UNITED STATES PATENT AND TRADEMARK OFFICE

APPLICATION NO.	FILING DATE	FIRST NAMED INVENTOR	ATTORNEY DOCKET NO.	CONFIRMATION NO.
10/773,571	02/06/2004	Martin E. Thiede	1088.154US02	3554

Office Action Summary	Application No. 10/773,571	Applicant(s) THIEDE, MARTIN E.	
	Examiner Yvonne M. Horton	Art Unit 3635

DETAILED ACTION

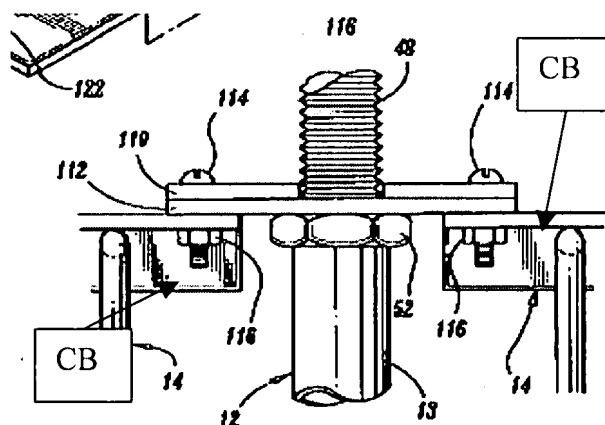
Claims 1,3-7,9,12, rejected under 35 U.S.C. 102(a) as being anticipated by US Patent #6,463,704 to JETTE. JETTE discloses a modular floor including at least two main beams (12) having an attachment structure including first and second sections (110,120) or (130,140) forming a channel (115) therebetween, at least one cross beam (CB) and floor panels (as at 10) that have a recess to receive (20) of beam (CB).

FIG. 2A

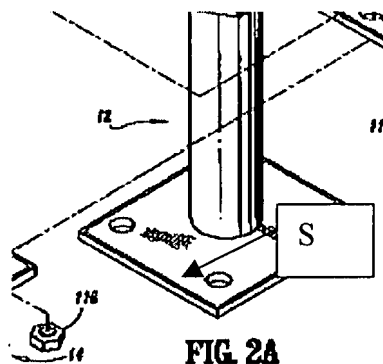
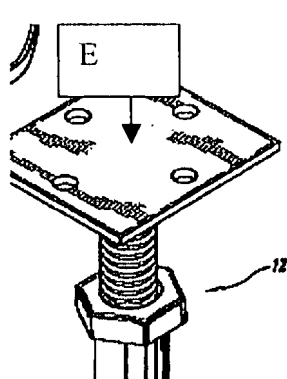
Regarding claims 3 and 9, bolts (48) and locking mechanism (52) are attached to the first and second ends of the main beam (12) by receipt of the bolt (48) within a recess (not labeled) formed in locking mechanism (52), see figure 2B. In reference to claims 5 and 6, the main beams include an extension (E) and a support (S) wherein the

extension (E) attaches to the attachment structure (110,120) Or (130,140). In reference to claim 7, the cross beams (CB) includes a main section (formed by 24,26,28) and ends (20).
